UN Regulation No. 10 (Electromagnetic Compatibility)

Proposal for a new 07 series of amendments to UN Regulation No. 10 (Electromagnetic compatibility)

Submitted by the expert from by the Informal Working Group on Electromagnetic Compatibility*

Figure 45
Vehicle in configuration "REESS charging mode coupled to the power grid"

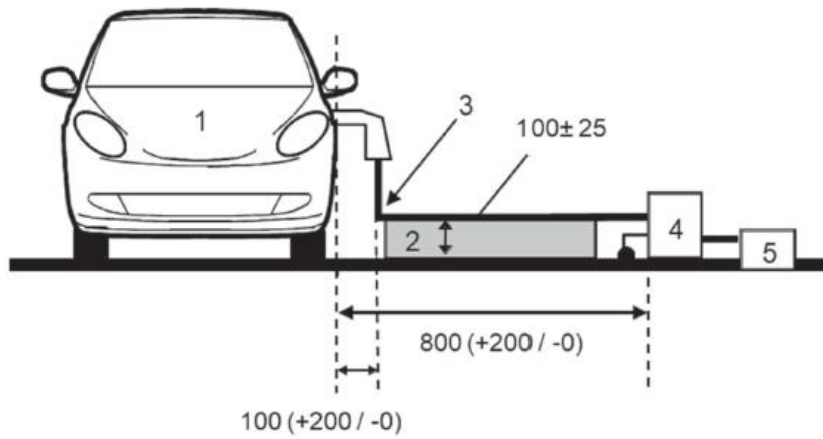
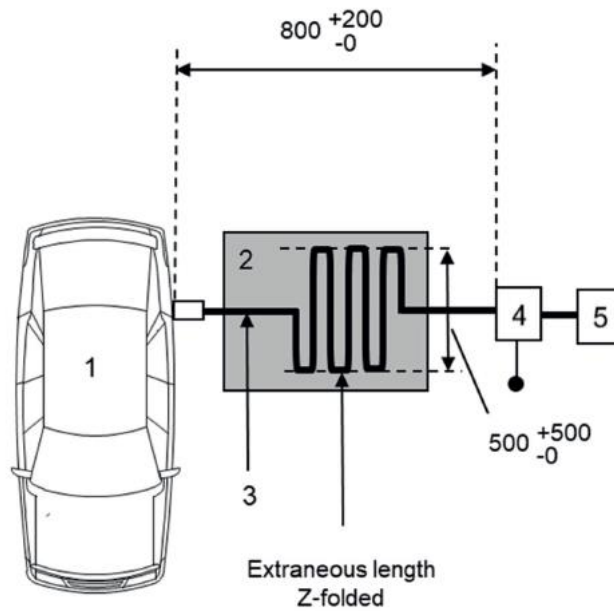
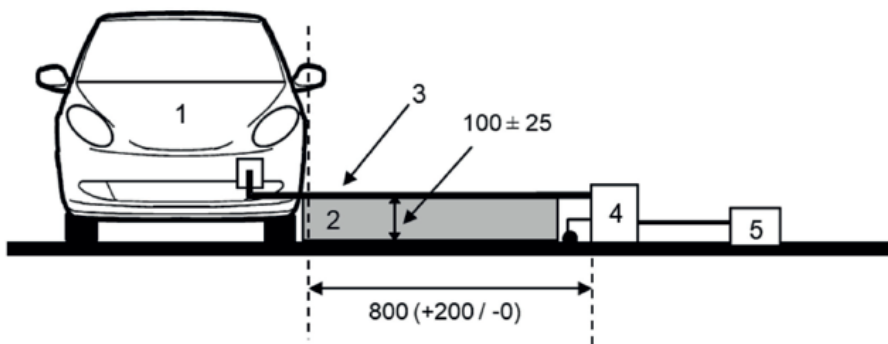
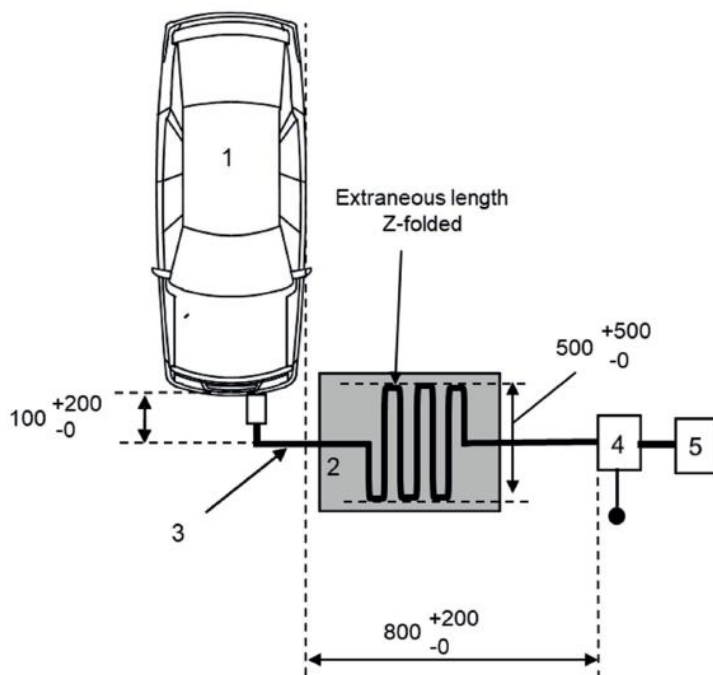
The power charging harness shall be placed in a straight line between the AMN(s) and the vehicle charging plug and shall be routed perpendicularly to the vehicle longitudinal axis (see Figure 3d5a and Figure 3e5c). The projected harness length from the side of the AMN(s) to the side of the vehicle shall be 0,8 (+0,2 / -0) m as shown in Figure 3d5b and Figure 3e5d.

Figure 5f

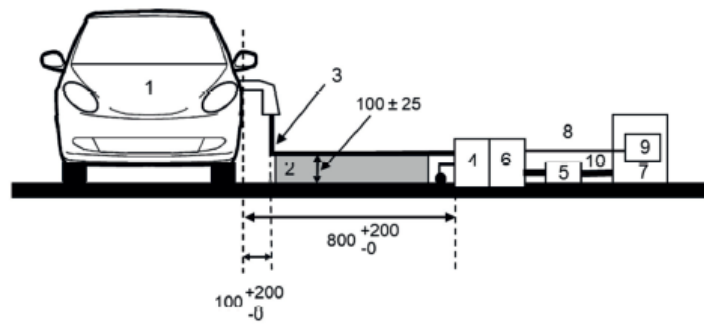
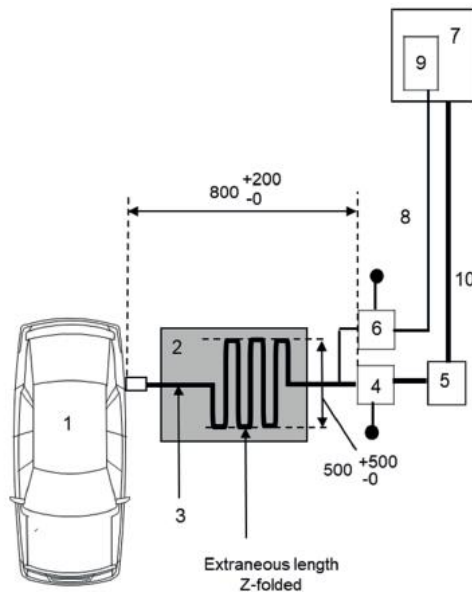
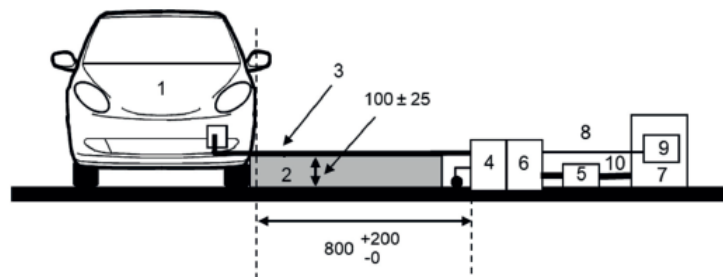
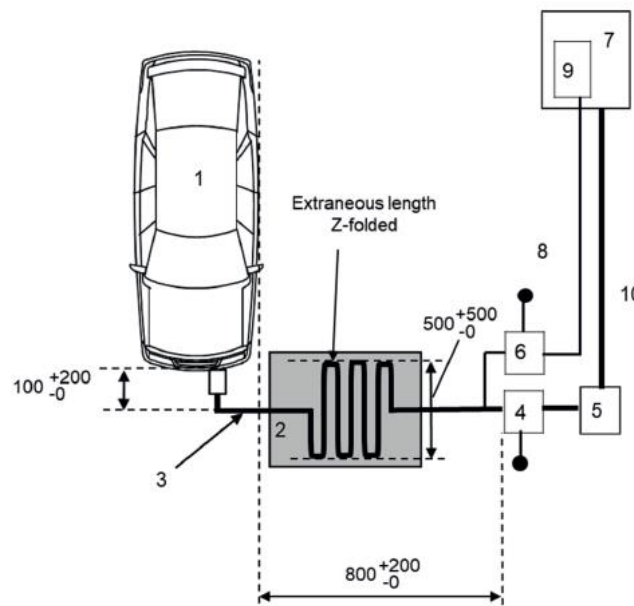
The power charging local/private communication harness shall be laid out in a straight line between the AMN(s) / DC-charging-AN(s) / AAN(s) and the vehicle charging socket and shall be routed perpendicularly to the vehicle's longitudinal axis (see Figure ~~3f~~**5e** and Figure ~~3g~~**5g**). The projected harness length from the side of the AMN(s) to the side of the vehicle shall be 0,8 (+0,2 / - 0) m **as shown in Figure 5f and Figure 5h.**

Figure 1
Charging mode configuration for Annex 11

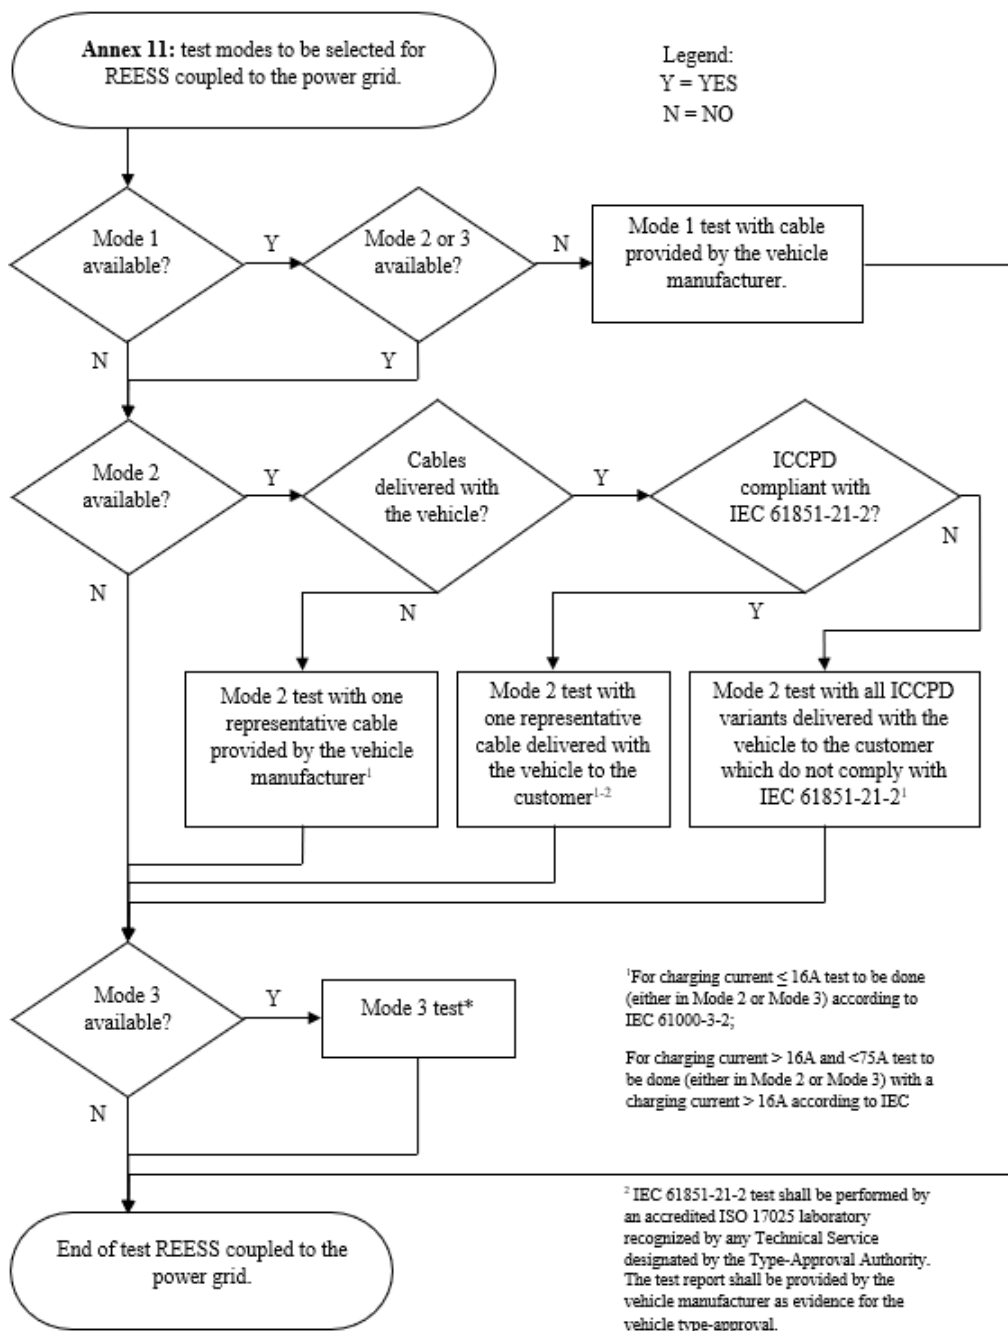
The vehicle shall be tested in the charging mode configuration (if available on vehicle) as defined in flowchart of figure 1

- (b) A flow chart was introduced for clarification of the charging mode configurations to be tested. For general explanation of the flow chart see Annex 4 with the following deviation:

"Figure 1b

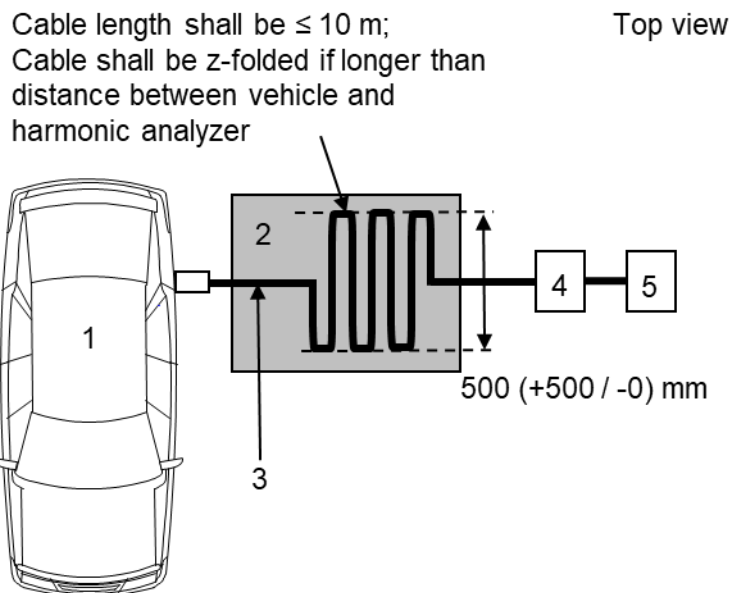
Annex 11, Appendix 1, Figure 1b, amend to read:

"Figure 1d

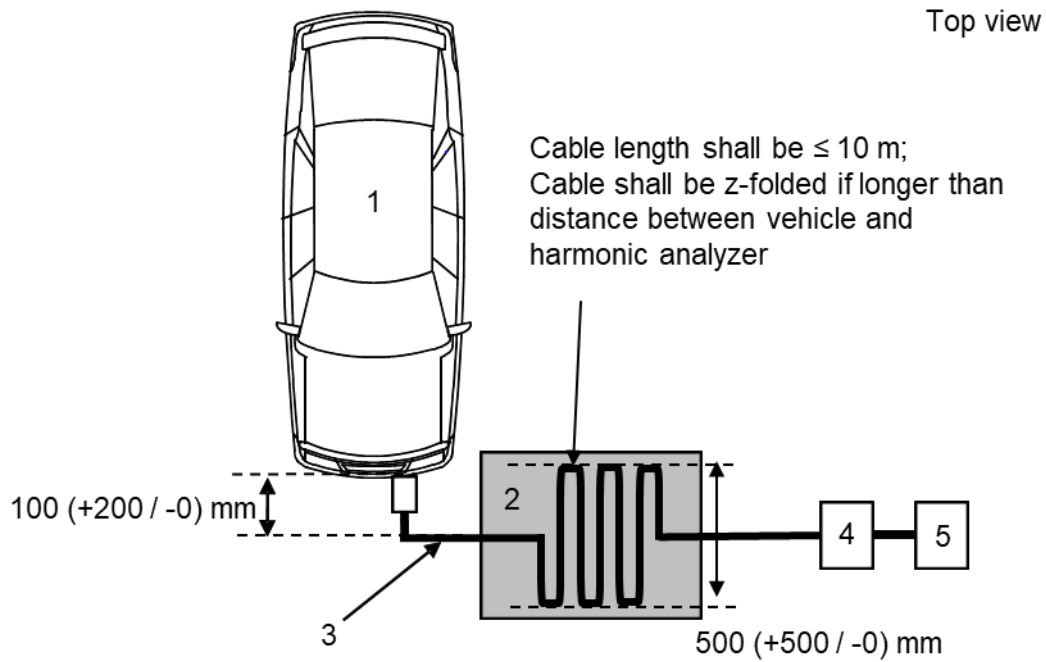
Figure 1d, amend to read:

- (c) Figures 1a and 1d were updated for consistency with international ISO (e.g. first edition of ISO 11451-5) and CISPR standards.
39. In Annex 12:
- (a) For two-wheeled vehicles, a non-conductive insulating support with a thickness of 5 – 20 mm shall be used between the stand and ground plane (see Annex 4).

Figure 1
Charging mode configuration for Annex 12

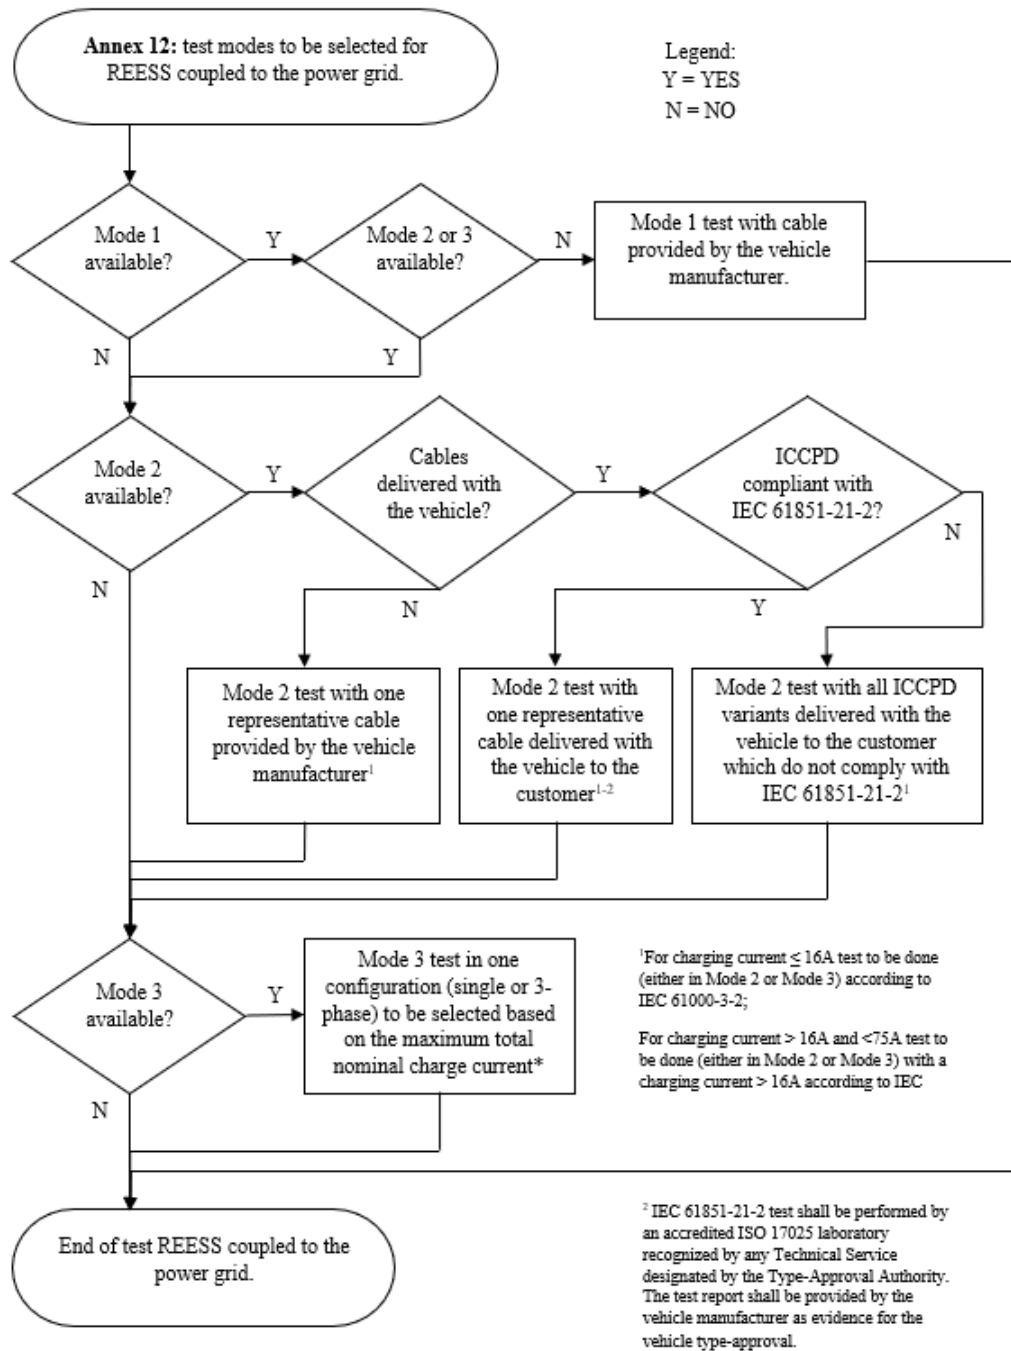
The vehicle shall be tested in the charging mode configuration (if available on vehicle) as defined in flowchart of figure 1

- (b) A flow chart was introduced for clarification of the charging mode configurations to be tested. For general explanation of the flow chart see Annex 4 with the following deviation:

"Figure 1b

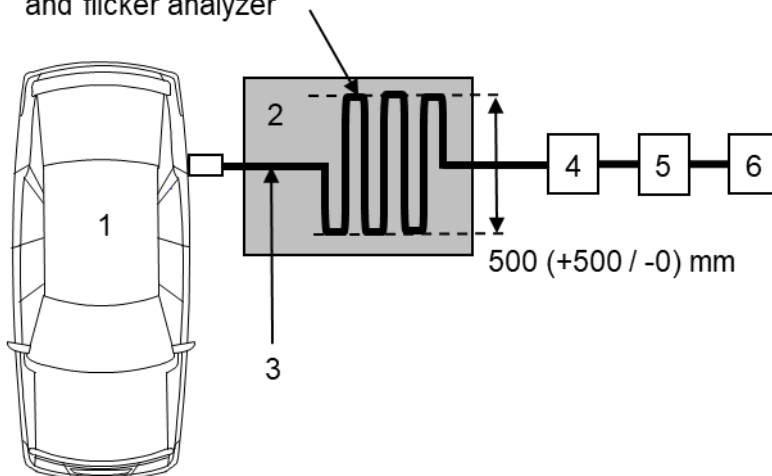
Figure 1b, amend to read:

Cable length shall be ≤ 10 m;
Cable shall be z-folded if longer
than distance between vehicle
and flicker analyzer

"Figure 1d

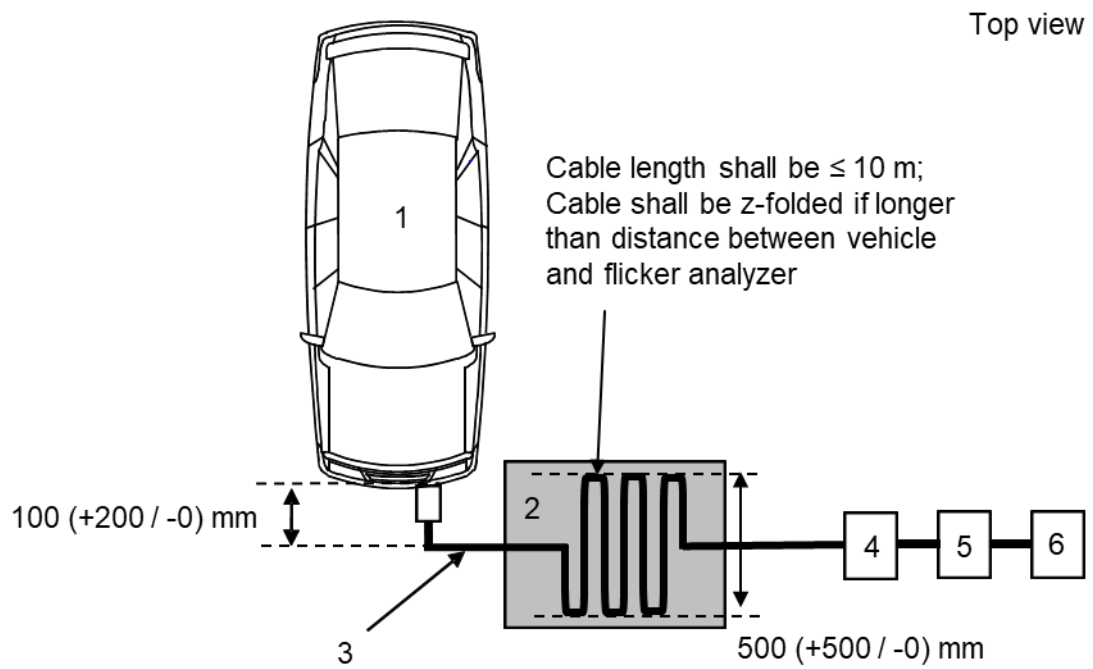
Figure 1d, amend to read:

- (c) Figures 1a and 1d were updated for consistency with international ISO (e.g. first edition of ISO 11451-5) and CISPR standards.
40. For Annex 13, see explanations to Annex 4.

Figure 1: Charging mode configuration for Annex 13

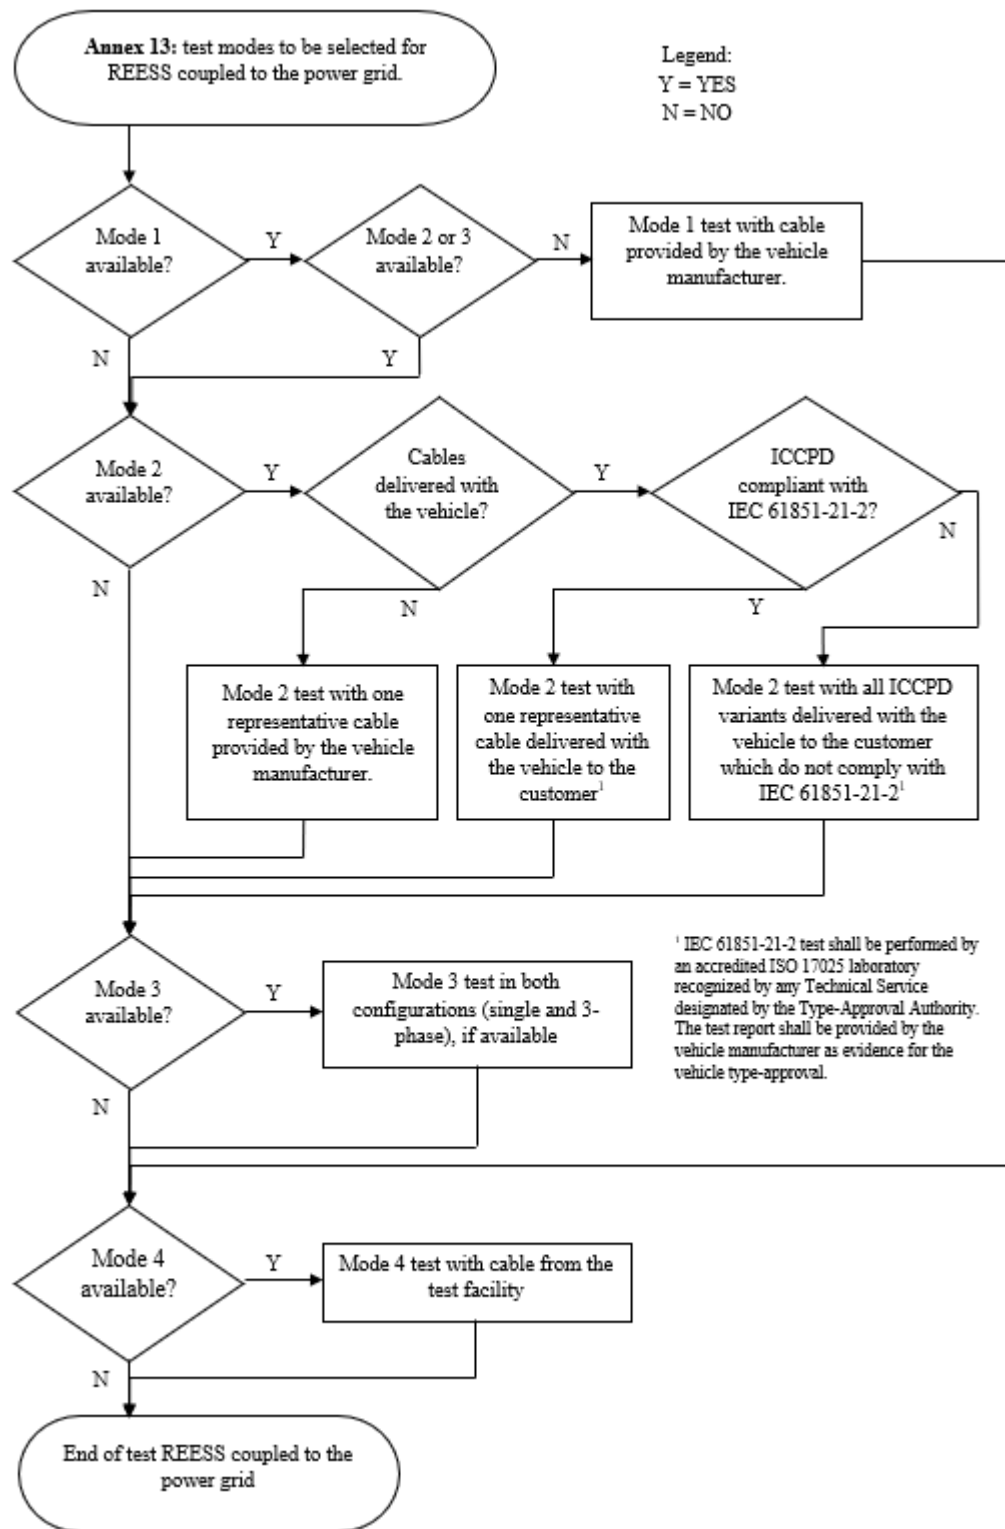
The vehicle shall be tested in the charging mode configuration (if available on vehicle) as defined in flowchart of figure 1

"Figure1b

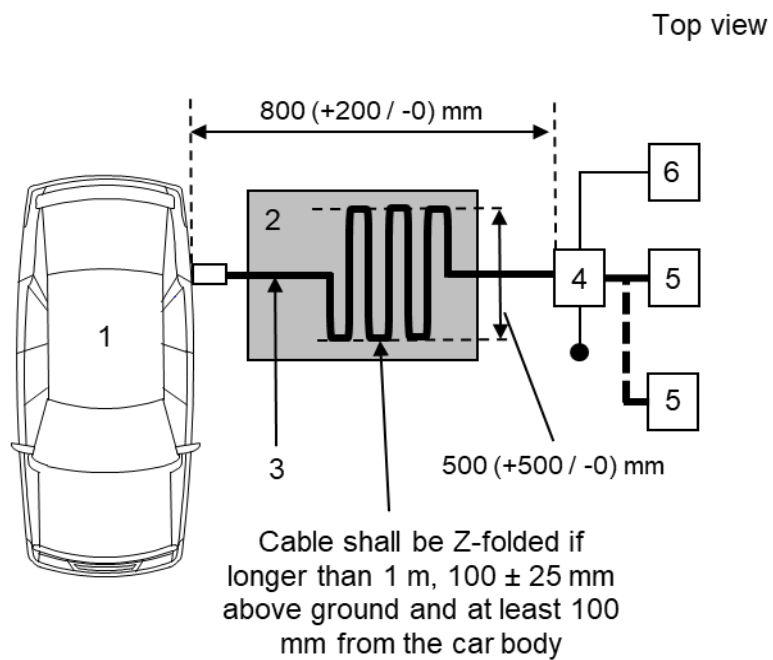
Figure 1b, amend to read:

"Figure 1d

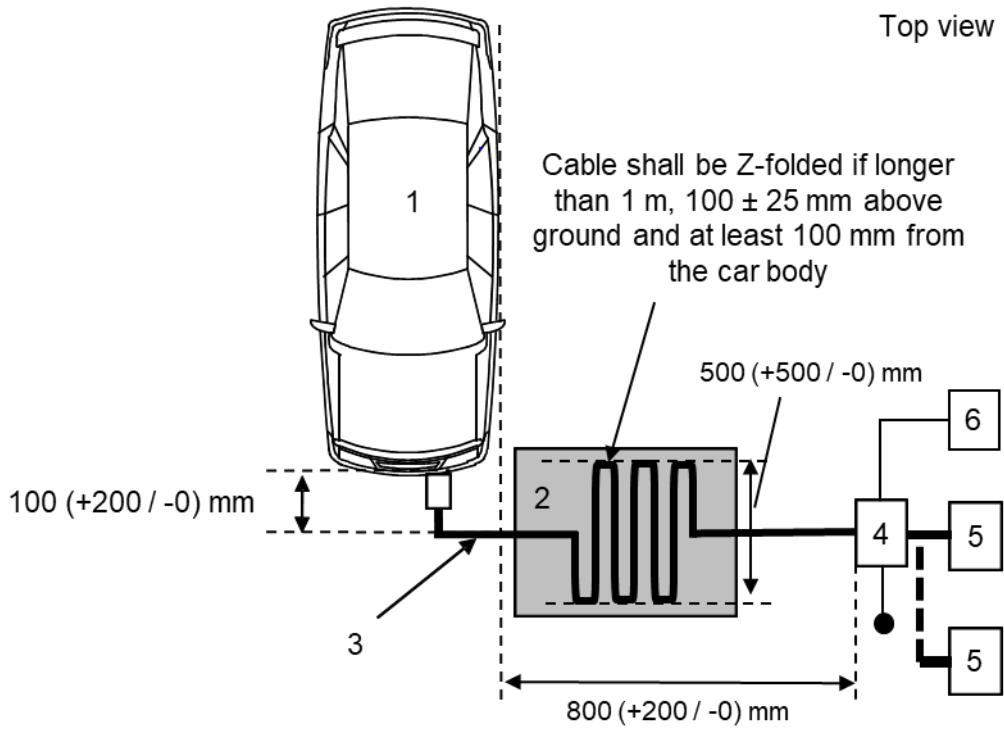
Figure 1d, amend to read:
